P16-0082 & P16-0083, Exhibit 3 - Aerial Photo/Location

DATE	DESCRIPTION
DRAWN BY: G. DE VERA	
CHK'D BY: F. COHEN	
DISPENSER AND CAR WASH ADDITION 1340 W. BLAINE STREET @ 60 FWY RIVERSIDE, CA. 92501	
<b>PROJECT NAME AND ADDRESS</b>

**RE: AIRPORT LAND USE COMMISSION (ALUC) DEVELOPMENT REVIEW –  
DIRECTOR'S DETERMINATION**

File No.: ZAP1223MA16  
Related File Nos.: P16-0082 (Conditional Use Permit), P16-0083 (Design Review)  
APN: 250-150-002, 250-150-013

LIGHTING PROPOSAL

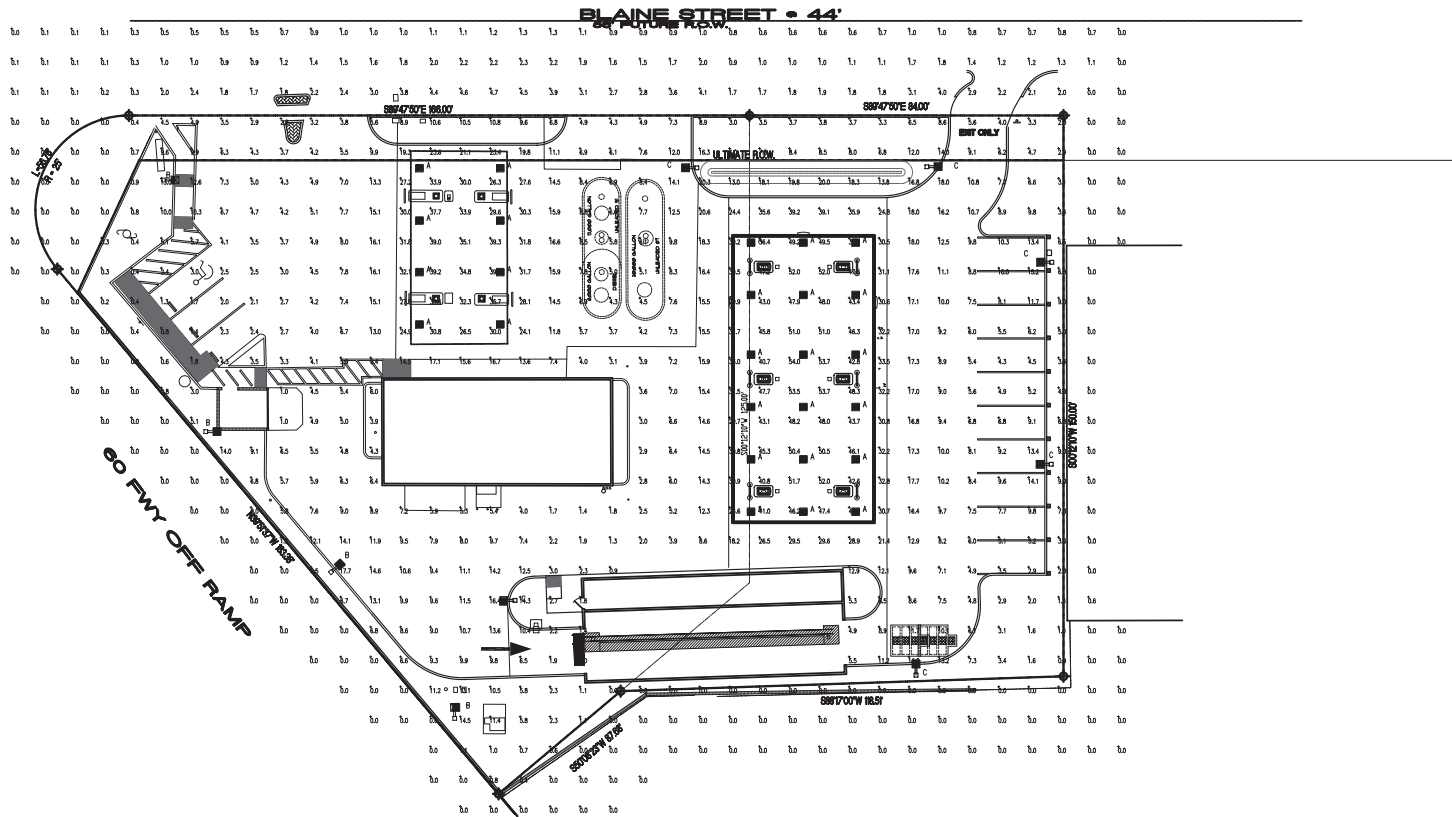
1. Any new outdoor lighting that is installed shall be hooded or shielded so as to prevent either the spillage of lumens or reflection into the sky. Outdoor lighting shall be downward facing.
